CORRECTION(S) TO WATER WELL RECORD (WWC-5)

Re: Corrected water Well Location
Monitoring wells KCC
McPherson County

RUNNING TURKEY CREEK
ERRORS IN THE FINAL REPORT BY T & C MFG OPER.

3 LOCATE WELL'S LOCATION WITH AN "X" IN SECTION BOX:

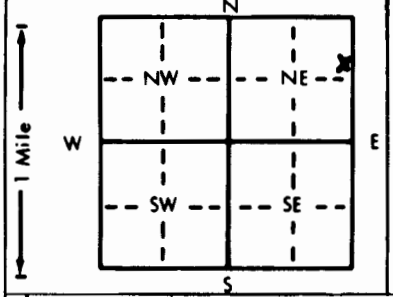
Location listed as:	**Location changed to:**
Section-Township-Range: 27 - 20 S - 3 W	26 - 20 S - 3 W
Fraction (¼ ¼ ¼): SE NE NE	W2 SW NW NW

Comments: Latitude: 38.28705° N, Longitude: 97.629589° W.
52' FWL 990' FNL.
